Midway City Planning Commission Regular Meeting Tuesday February 12, 2019

NAME OF PROJECT: LaBarge Subdivision

NAME OF PROJECT: Hidden Haven Subdivision

Subject: **Hidden Haven Subdivision – Preliminary Review**

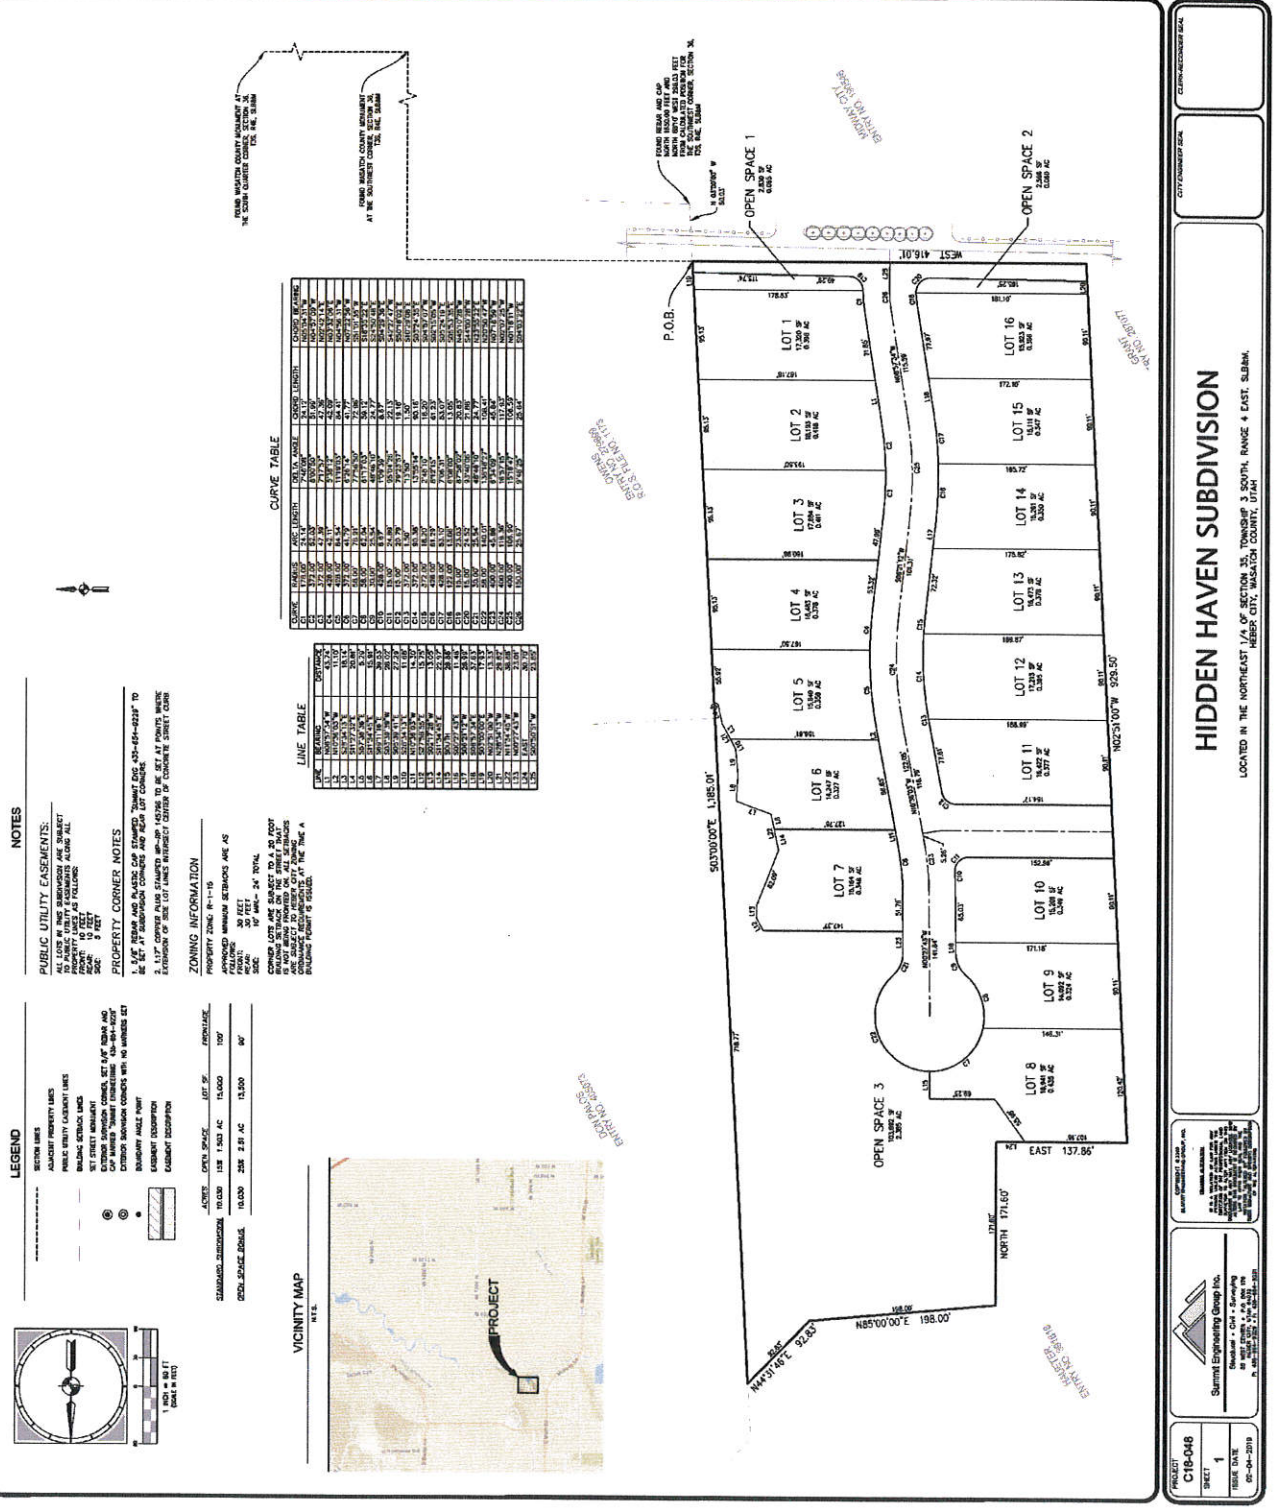
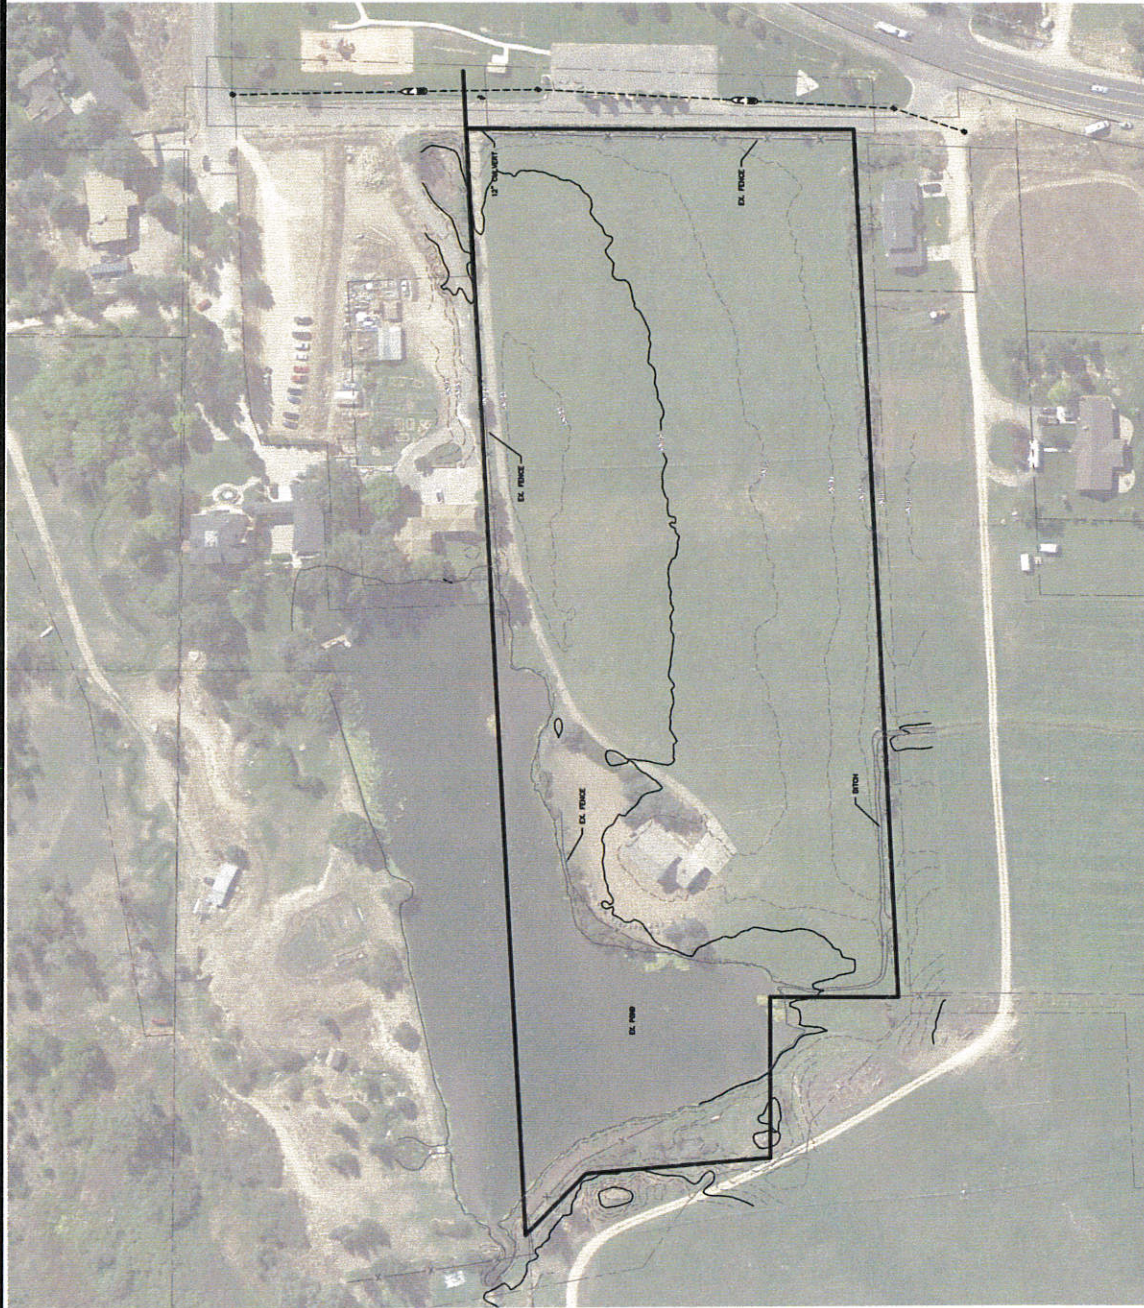
- The subdivision is located at approximately 800 East, East Main Street. The proposed development consists of sixteen lots.
- A geotechnical report should be submitted.

- The subdivision is proposing to install a cul-de-sac that exceeds the Construction Standard Limits of 500'. However, within the cul-de-sac is a road stubbed Haueter property, providing a second point of access. Prior to approval an agreement should be recorded indicating the Haueter's intent to extend the road in the future to a through road.
- The plat should have a note indicating no public services will be provided on the stub road until it is extended and connected to a through road.
- The roadway cross-section within the proposed subdivision should provide the standard roadway cross-section with a 56' right-of-way. This cross-section should have a 5' sidewalk, a 5' park strip, with the standard modified curb & gutter.
- The road within this subdivision will be a public road.

- Final plans will show the design of the public storm drain system.
